SERVICE BULLETIN

N° 139-684

DATE: November 10, 2021

ATA 93 - TURRET FLIR UNIT REPLACEMENT

Figure 1

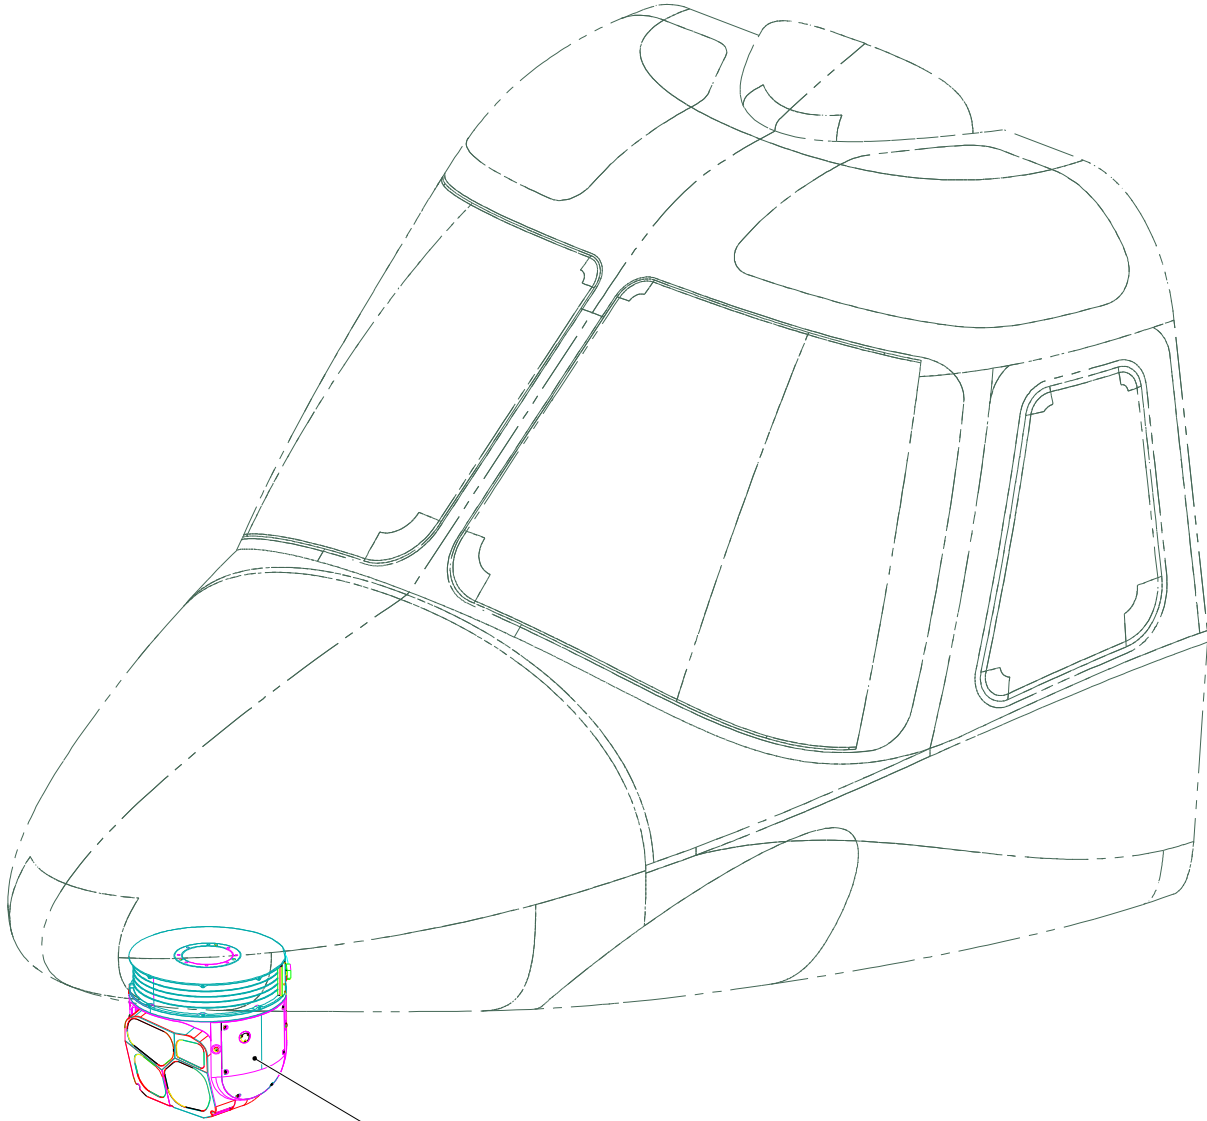
This Service Bulletin gives instruction to replace the FLIR SS380 HDc TFU P/N 3G9350I01231 with the FLIR SS380 HDc TFU P/N 3G9350I02031.

- 2.1 With reference to Figure 1, disconnect the connectors and remove the FLIR SS380 HDc TFU vendor control drawing P/N 3G9350I01231 from the helicopter. Retain hardware for later reuse.

- 2.2 With reference to Figure 1, carefully lift the FLIR SS380 HDc TFU vendor control drawing P/N 3G9350I02031 until it is against the quick plate on its housing.

- 2.3 With reference to Figure 1, attach the FLIR SS380 HDc TFU vendor control drawing P/N 3G9350I02031 to the quick plate by means of existing hardware previously removed. Connect the connectors to the FLIR SS380 HDc TFU vendor control drawing.

REMOVE:
3G9350101231 FLIR SS380 HDC TFU VENDOR CONTROL DRAWING
INSTALL:
3G9350102031 FLIR SS380 HDC TFU VENDOR CONTROL DRAWING
(USE EXISTING HARDWARE)
